***Delegated Decisions by Cabinet Member for
Environment (including Transport)***

***Thursday, 19 December 2019 at 10.00 am
County Hall, New Road, Oxford***

4. Oxford/North Hinksey: Botley Road & West Way - Traffic Measures (Pages 1 - 92)

Report by Director for Community Operations (Interim) (**CMDE4**).

Statutory Consultation Drawings (Sheet 3 of 5)

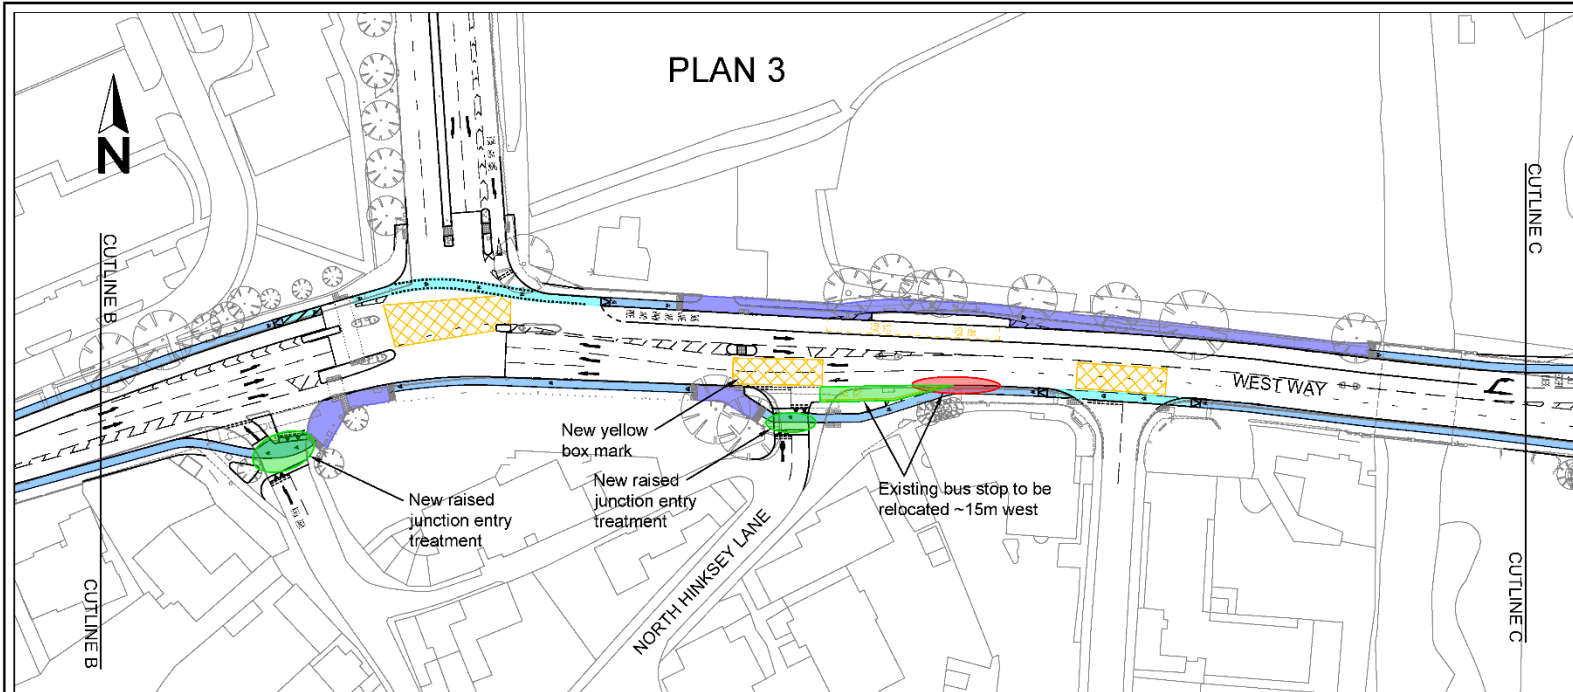
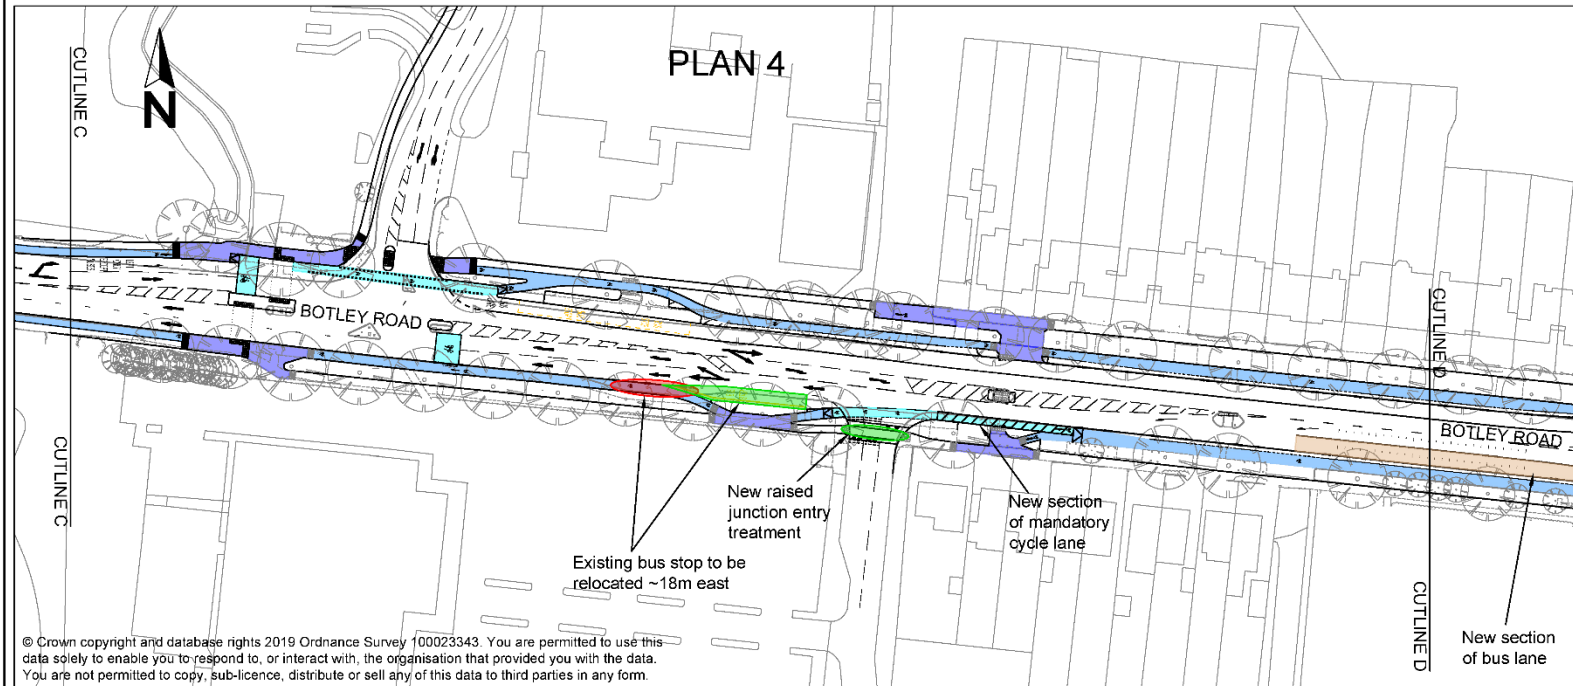
<p>June, that a small traffic island be installed within the hatched area to prevent this overtaking movement. Has this been considered and if so what reason was it discounted?</p> <p>Plan 3 of 5 Why does the yellow box marking only protect the A420 Slip Road/West Way junction inbound? During heavy traffic periods queues for the West Way/Westminster Way junction tail back into this junction which can have a knock on effect for traffic turning right from the slip road. This queuing is likely to become more frequent once the development of the West Way shopping area is complete.</p> <p>Plan 4 of 5 I object to the removal of the bus stop outside Waitrose. Bus passengers going to or from Waitrose using this stop have an access from the rear of footway, by the bus stop, into Waitrose. With the relocation those passengers will need to cross the traffic entering and exiting Waitrose. This is an unnecessary increase in risk for those pedestrians.</p> <p>Plan 5 of 5 What is the logic behind moving the bus stop on the north side of the road further west? It looks as though the entry taper to the bus stop affects the entry/exit to the West Oxford Community Centre. At times when more than one bus stops at the stop the entry/exit will be blocked.</p>

(129) Oxford City Council	Comments	<p>On the north side of Botley Road, Plan 3 indicates a proposed short section of off-carriageway un-segregated cycle route approaching the junction access to Seacourt P&R. The plans indicate the continuation of this off road provision beyond this junction but a raised junction entry treatment is not proposed in this location.</p> <p>Plan 3 appears to suggest that cyclists wishing to access Seacourt Park and Ride from the east (City direction) can use the advanced stop line or the crossing beyond the access junction. The existing crossing is</p>

<p>straight whereas the proposed appears to be staggered. This makes it less useful and is very unhelpful for cyclists wishing to cross. This crossing should be a Toucan crossing. The turn from Botley road across the junction is no good for less confident cyclists as they have to cross moving traffic to access the turning lane. Hence a toucan crossing is essential.</p> <p>We note that Plan 4 indicates a new section of on-carriageway mandatory cycle lane on the south side of Botley Road to the east of the access road to Wickes/ Aldi. The plan appears to show the removal of the existing off-carriageway segregated cycle route in this location. The benefit of the proposed short section of on-carriageway cycle lane is unclear given the absence of any further on-carriageway cycle lanes approaching this. Furthermore, the removal of the existing off-carriageway segregated route in this location will put more vulnerable cyclists at risk of conflict if they are encouraged to continue their journey on carriageway at this point.</p> <p>We note the new outbound section of bus lane that is proposed to the west of Lamarsh Road (Plan 4). The provision of this involves the loss of a large section of the existing right-hand turn lane. This lane not only provides access to the retail parks to the south of Botley Road but also to residents of Lamarsh Road and Brook Grove. Have the impacts of the removal of a large section of this right-hand turn lane been modelled on the predicted in-bound traffic delays, particularly during the weekend peaks?</p> <p>We note that Plan 6 indicates the provision of a new toucan crossing to replace the existing refuge. This crossing is not on the desire line for pedestrians wishing to access Waitrose. Furthermore, the plans do not indicate whether pedestrians and cyclists are given priority over vehicles accessing Waitrose. This junction should have a raised junction entry treatment like the other junctions and signage should be provided to ensure priority is given to pedestrians and cyclists. Would it be worth considering a further extension to the west of the proposed 20mph zone from Binsey Lane that it covers the entrance to Waitrose thus providing further protection for vulnerable road users in this area?</p>

Drawing title HIGH STREET, LONG WITTENHAM CYCLE BY-PASS IN EXISTING BUILDOUTS					
Drawing Status					
Scale @ A3 1:200	Drawn by SRF	Checked by LMD	Approved by AJP		
	Date drawn 19.01.12	Date checked 03.02.12	Date approved 08.02.12		
Oxfordshire Project No. & File Ref S-000579

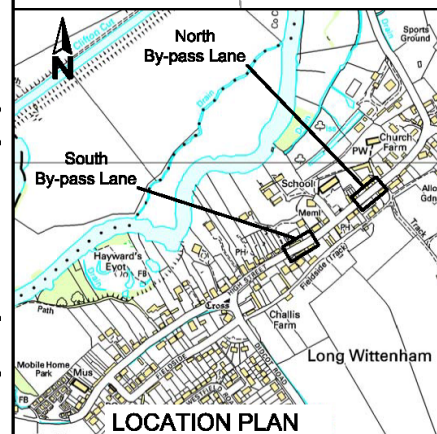
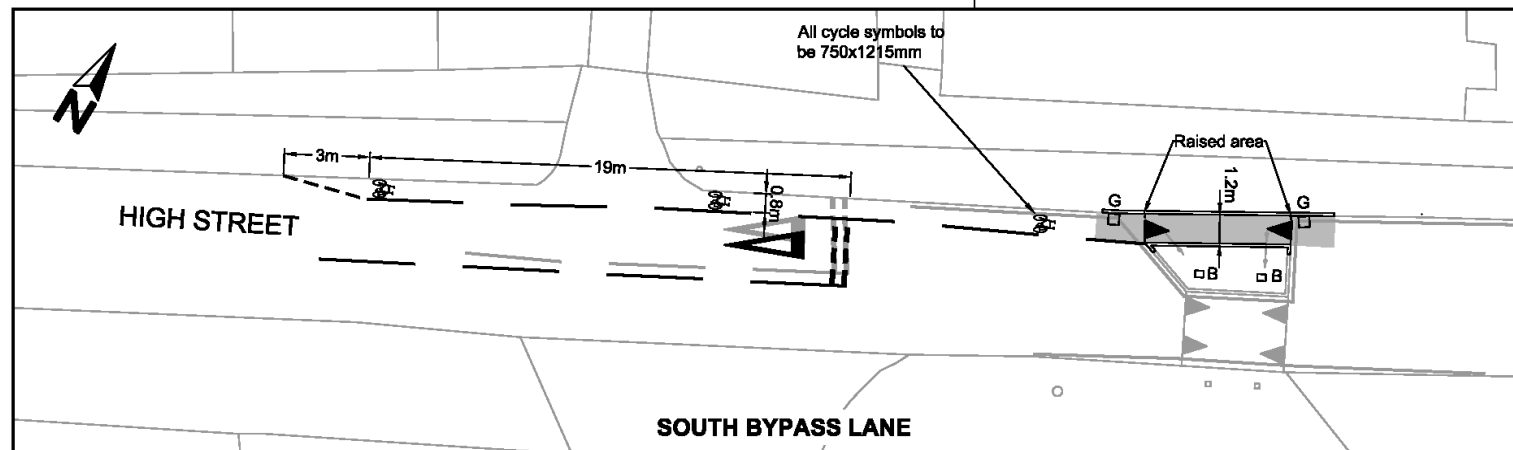
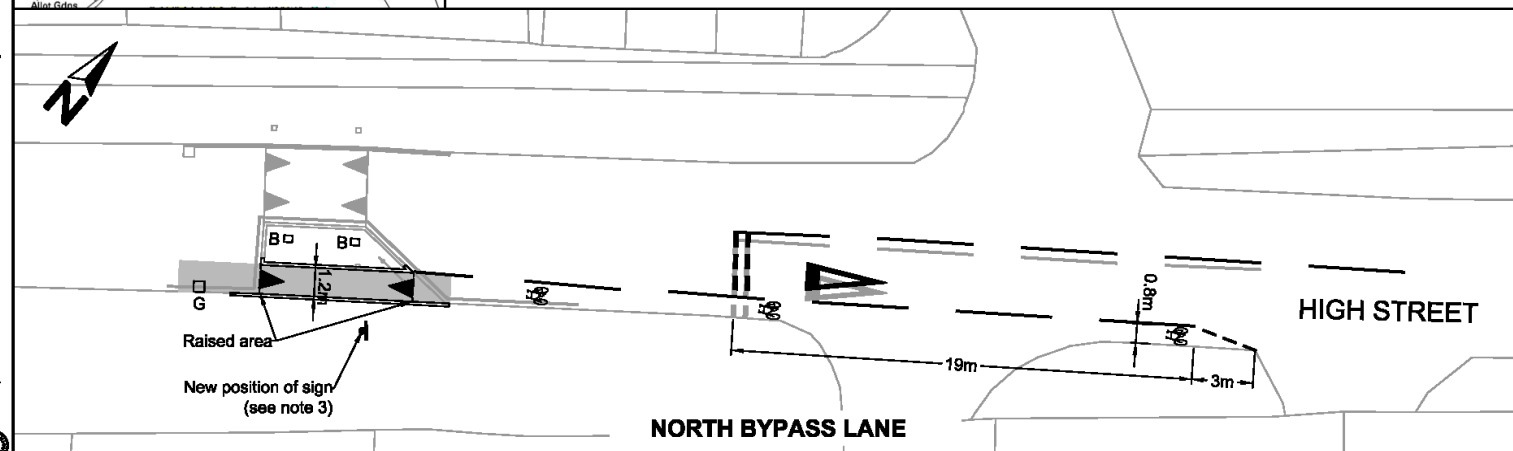
14. Expressions of qualified support were received from HARBUG and the Oxfordshire Cycling Network, who though also noted concerns about the narrow width of the cycle provision, in particular the 0.8m width advisory cycle lanes on the approaches to the cycle bypasses and also the need to provide a cycle lane on the exit from the bypasses, together with measures to prevent parking in the immediate vicinity by providing waiting restrictions possibly also supplemented by kerbing to ensure compliance by drivers. Concerns were also expressed that without adequate maintenance the bypasses would be prone to the accumulation of debris etc.

The PC looked at your plans and the description above and found there is an immediate discrepancy in the width described. On the plans the new lanes are marked 0.8m and above you state approx 1.2m?

9. In response to the above concerns the design will have a humped bypass lane making it less likely to become cluttered with debris.
10. Long Wittenham Parish Council objected on the grounds that the width of the cycle provision – including both the advisory cycle lanes on the approach and the cycle bypasses – was inadequate and could present a hazard to cyclists, including encouraging cyclists to pass stationary traffic on its nearside and on re-joining the carriageway after passing through the build-out and a more general concern that the proposals were inconsistent with the Neighbourhood Development Plan – adopted jointly by the parish council and South Oxfordshire District Council – which includes a significant environmental enhancement to the village, including addressing traffic congestion at peak periods, taking account also of the planned relocation of the primary school and the provision of an off-carriageway route for pedal cyclists to avoid the High Street.

12. Noting the above concerns it is accepted that although the limited width of the road precludes cycle provision meeting current standards and also that there will be, in practice, times that the cycle lanes may not be passable due to traffic conditions, provision is considered to be an improvement and a relatively low cost measure that in no way jeopardises longer term improvements contained within the Neighbourhood Development Plan.
